LAKEVIEW VILLAGE

LAKEVIEW VILLAGE - STANDARD CURB & SPLASH PAD

LAKEVIEW VILLAGE RIGHTS-OF-WAY NOVEMBER 10, 2020 MEETING WITH MISSISSAUGA/PEEL STAFF REGARDING UNDERGROUNDS

Typical Lakeview Street Section

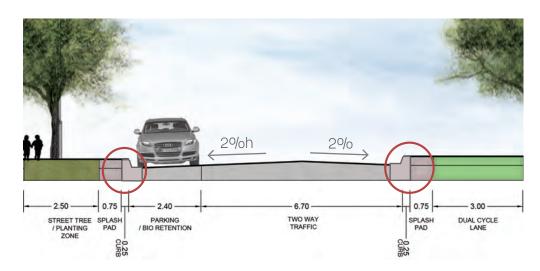
Sections have been revised to show a barrier curb with gutter. These will incorporated with a special splash pad detail to create a unique sense of identity through the detail-design of streetscape elements.

STREET 'I' SOUTH OF STREET 'B'
LAKEVIEW COMMUNITY - MISSISSAUGA

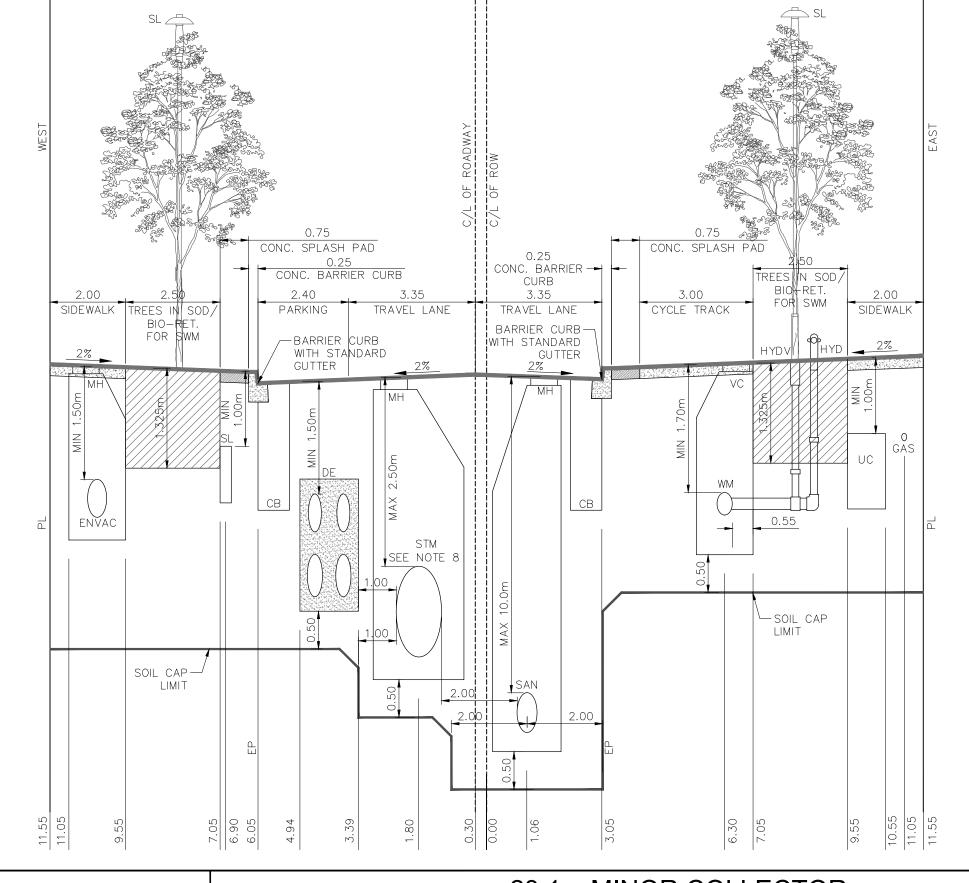
- Figure 7 (22.2m Minor Collector) cross-section previously represented Street 'I'. In the current submission we have split this cross-section into two, one for each section of Street 'I' north and south of Street 'B'. This change was made for the following reasons:

- Sanitary sewers were added below the travel lanes.
 - Street 'I" south of Street 'B':
 - No changes to placement of below ground utilities from previous version.

23.1m MINOR COLLECTOR
STREET 'A' BETWEEN STREET 'I' & STREET 'H'
LAKEVIEW COMMUNITY - MISSISSAUGA

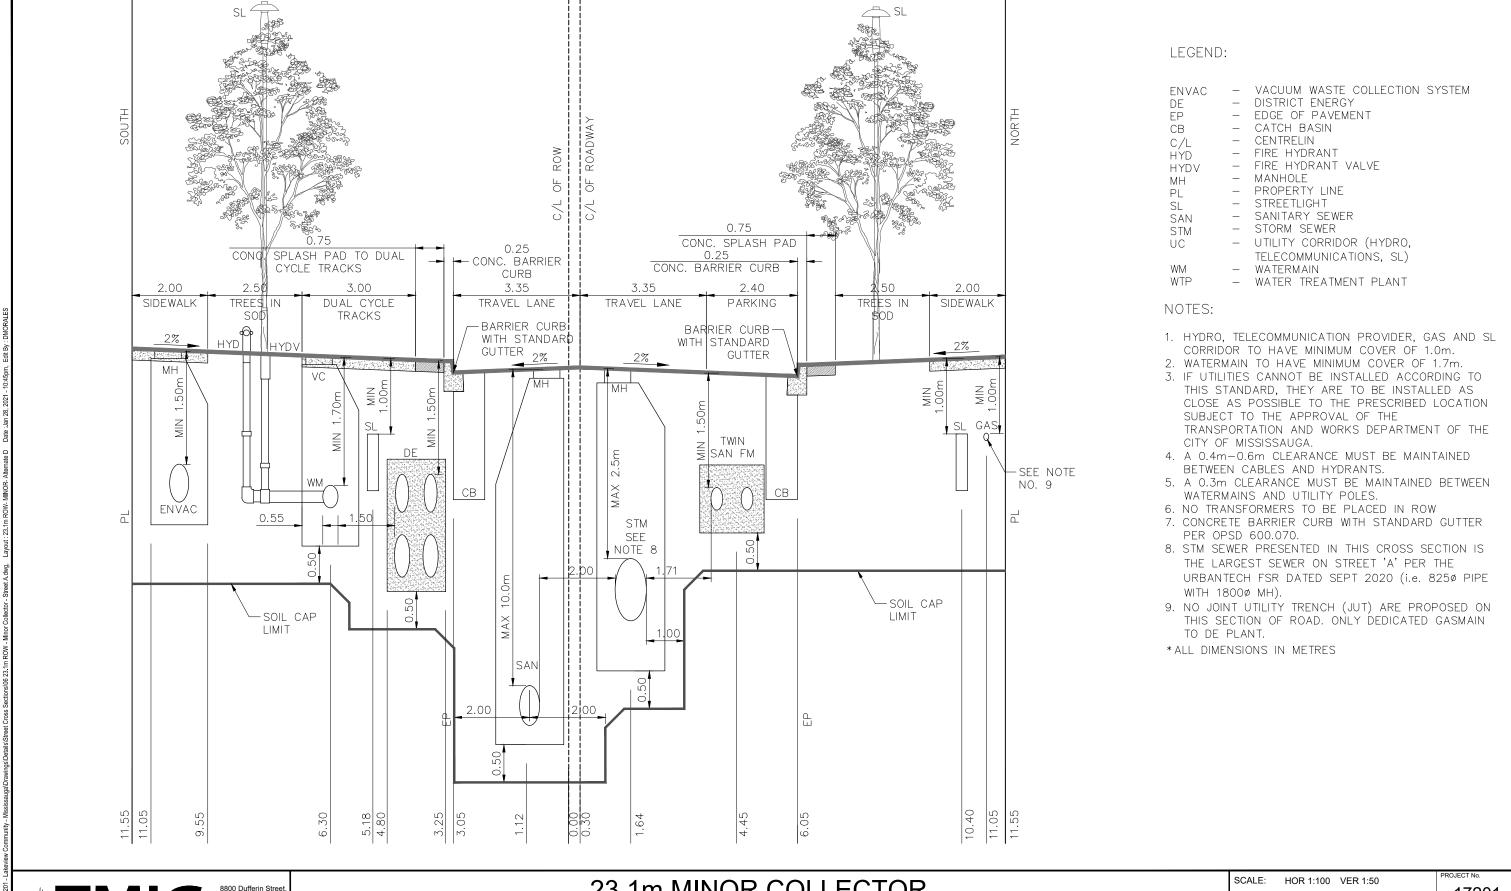
- Figure 8 (22.0m Minor Collector) cross-section representing the section of Street 'A' between Street 'I' and Hydro Road was updated to address City comments on surface features, but these revisions did not impact placement of below ground utilities.

STREET 'G' BETWEEN STREETS 'A' & 'D' LAKEVIEW COMMUNITY - MISSISSAUGA

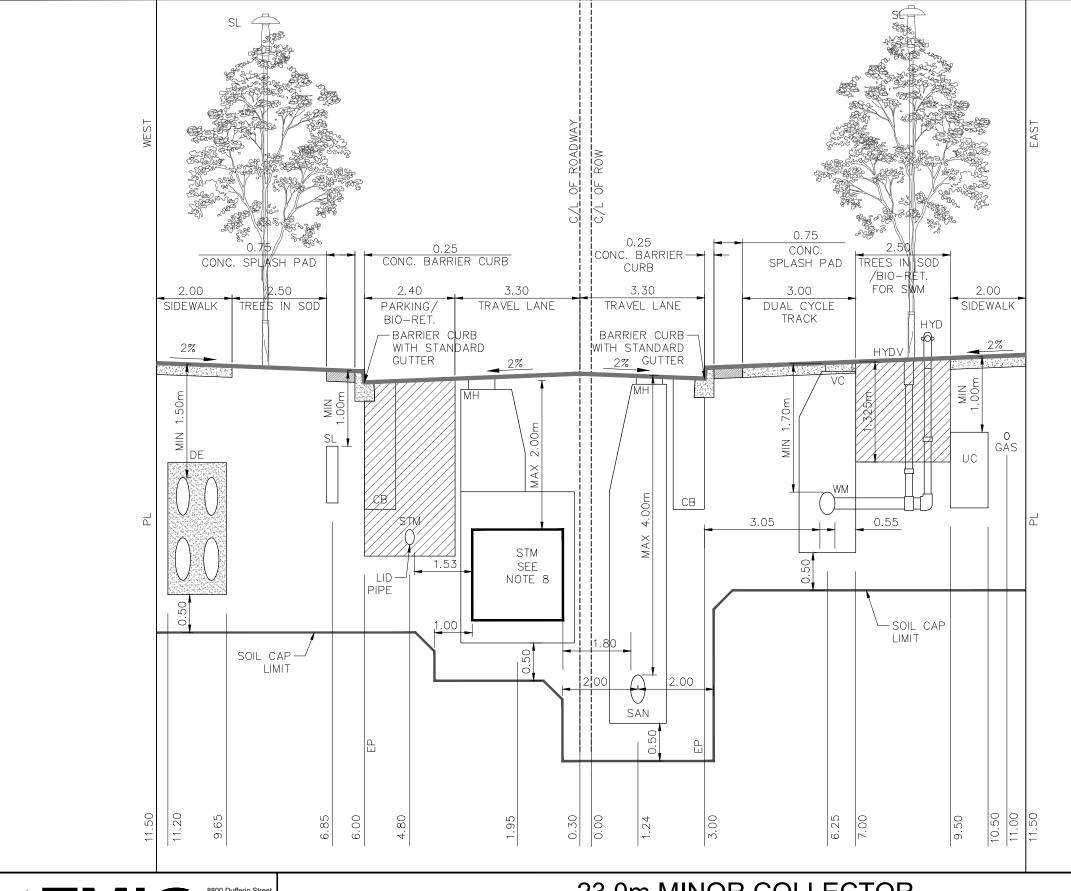
- o Sanitary sewers are proposed in Street 'A' ROW but not Street 'K'.
- Figure 2 (22m Minor Collector cross-section representing Street 'G' has been updated per the following:

- o The District Energy pipe system has been moved to under the sidewalk whereas previously they were proposed under the cycle tracks.
- Figure 3 (18.0m Local Road) cross-section previously represented all the local roads within Lakeview Village. In the current submission we have split this cross-section into three, one for each of Street 'D', Street 'H', and Streets 'C', 'E', and 'J'. The only change for below ground utilities was in Street 'H', where there is no sanitary sewer proposed.

STREET 'F'
LAKEVIEW COMMUNITY - MISSISSAUGA

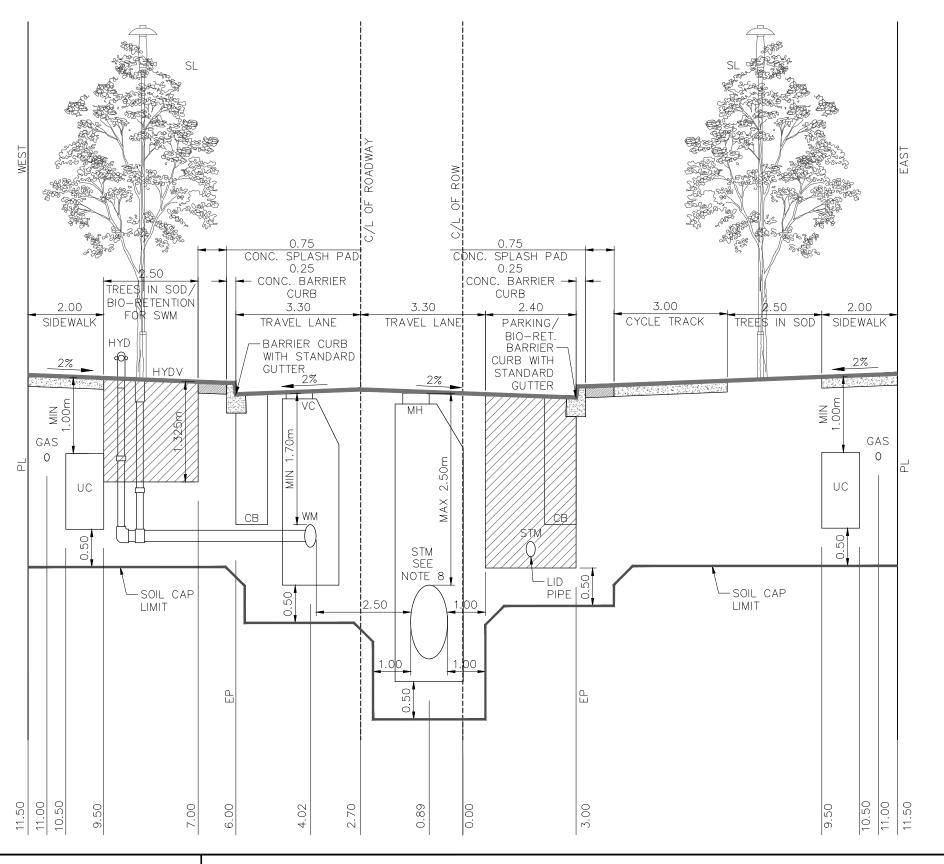
- Figure 5 (22m Minor Collector) cross-section representing Street 'F' was updated to include cycle tracks and one fewer lay-by parking / LID lane. The only change to the below ground utilities was the removal of LID on the west side of the roads and adjusting the distance between storm sewers and watermain.

22.4m MINOR COLLECTOR
STREET 'B'
LAKEVIEW COMMUNITY - MISSISSAUGA

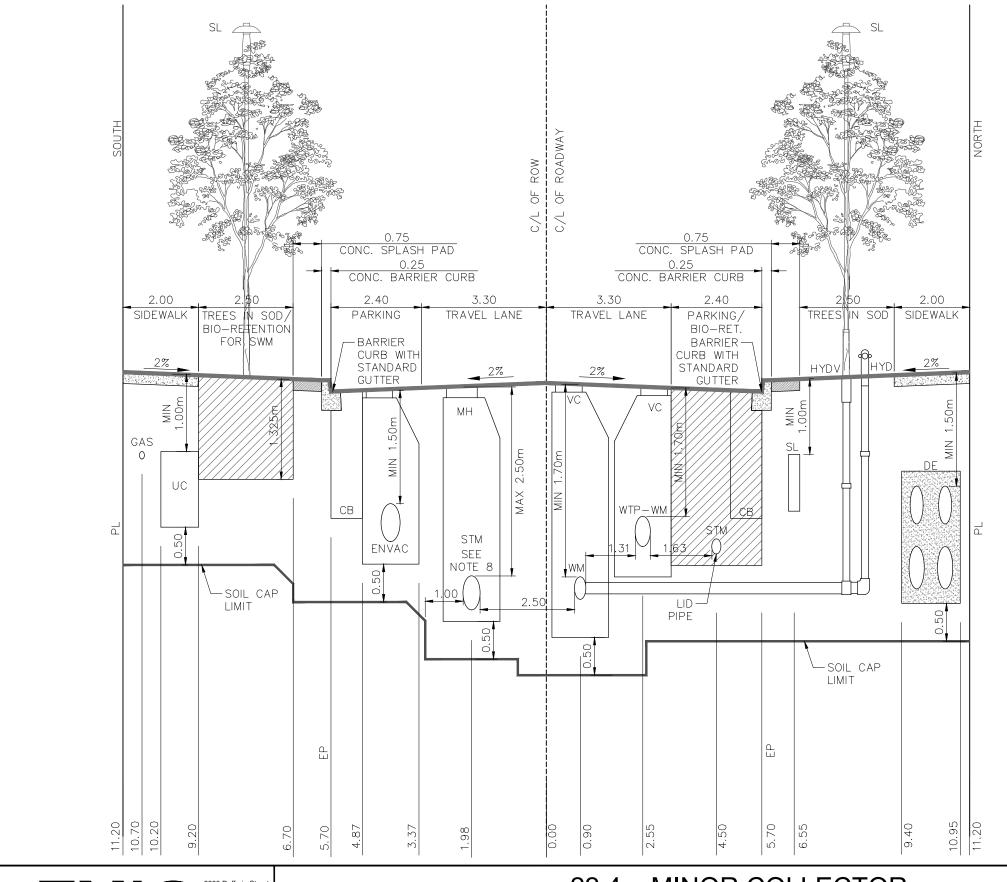
- Figure 6 (22m Minor Collector) cross-section representing Street 'B' was updated to address City comments on surface features, but these revisions did not impact placement of below ground utilities.
